**PAQUETTE PLANNING ASSOCIATES LTD.**  
**URBAN PLANNING AND LAND DEVELOPMENT CONSULTANTS**

**Re: Zoning By-law Amendment D02-02-21-0008 and Site Plan Control D07-12-21-0015**  
**120 Den Hagg Drive**  
**Phase 1**

Please accept this fourth submission for site plan approval for the above referenced project as a follow up to your circulation comments received on March 6 and 16, 2023. To this end, attached are the following documents for your information:

## Circulation Comments and Responses

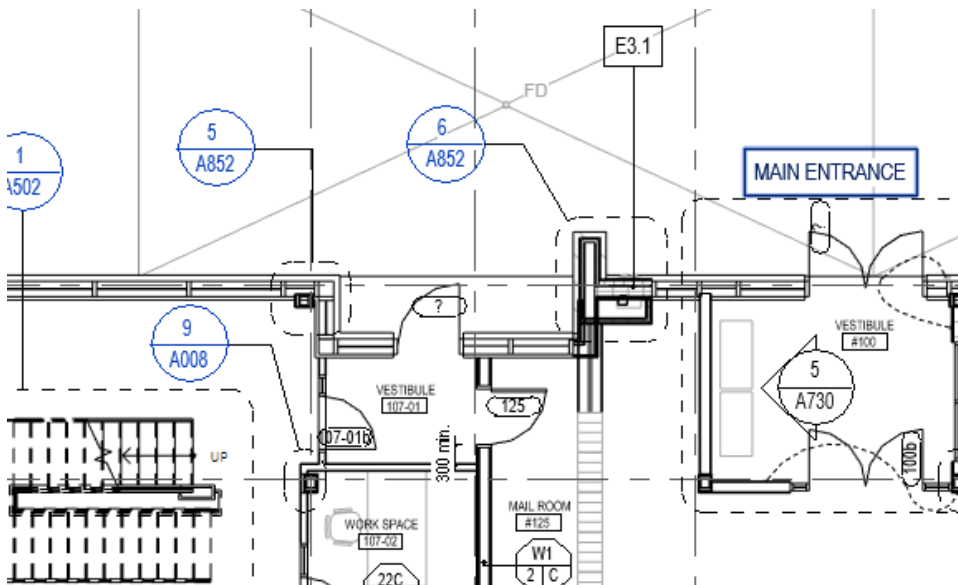
1. The eastern sidewalk along Den Haag is in disrepair with some grading issues noted. Please include the repair in the scope of works.

**Response:** Noted. Sidewalk to be added to scope of work for 120 Den Haag. Existing sidewalk to be removed and replaced in existing location based of city's standard details.

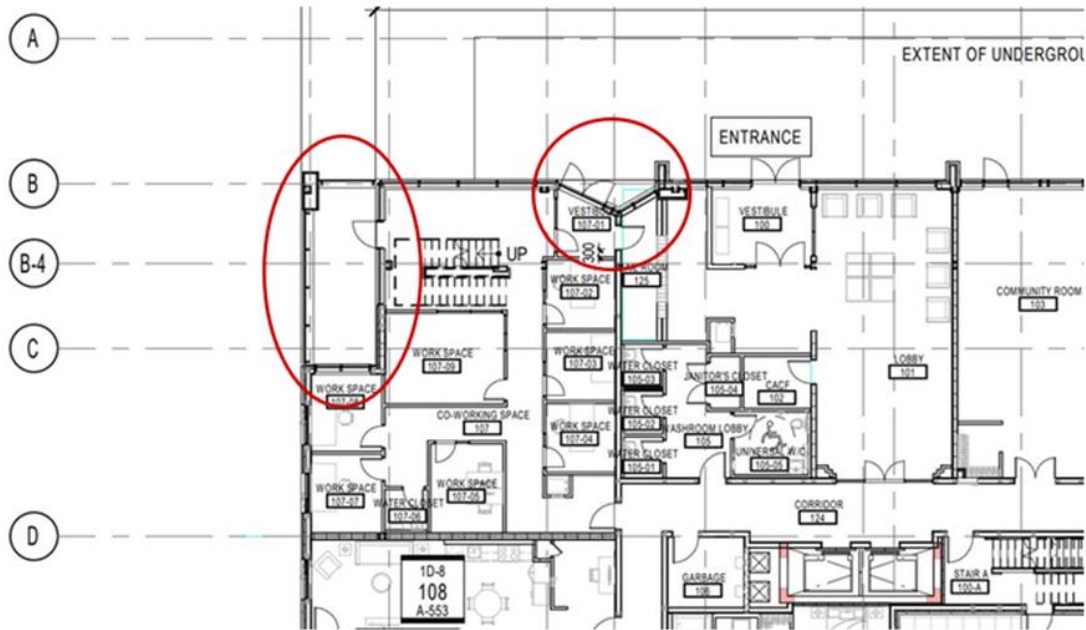
- It is preferable to have these lockups in the courtyard instead of a main frontage like Montreal Road.

**Response:** Noted.
